PARTS & SERVICE NEWS

REF NO. AA01119A

SUBJECT: UPGRADE OF ECM CALIBRATION AND NEW CPL FOR QSK19 ENGINE

PURPOSE: To introduce new injectors for performance improvement.

Wire connections for the new compact fuel pump.

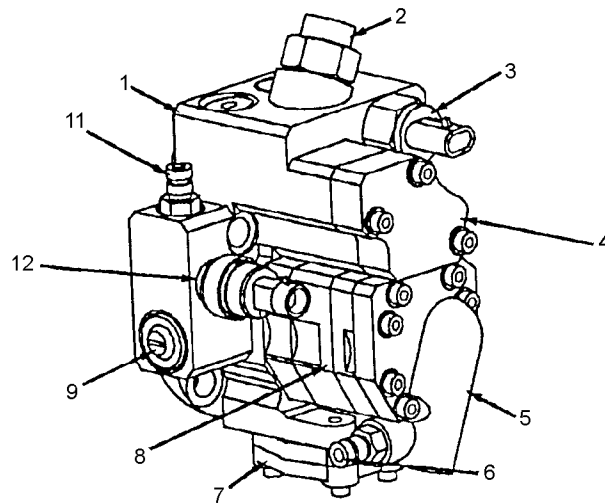
Final installation of new components are shown above.

Fig. 1. New Injector Copper Seal, Split Tang (1)

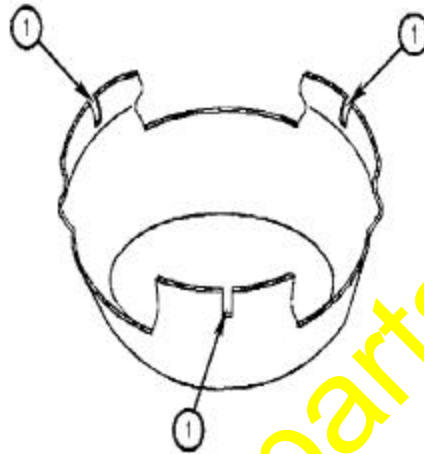
The new design of the new injector copper seal has a split in each of the tangs and is not interchangeable with the older injector copper seals.
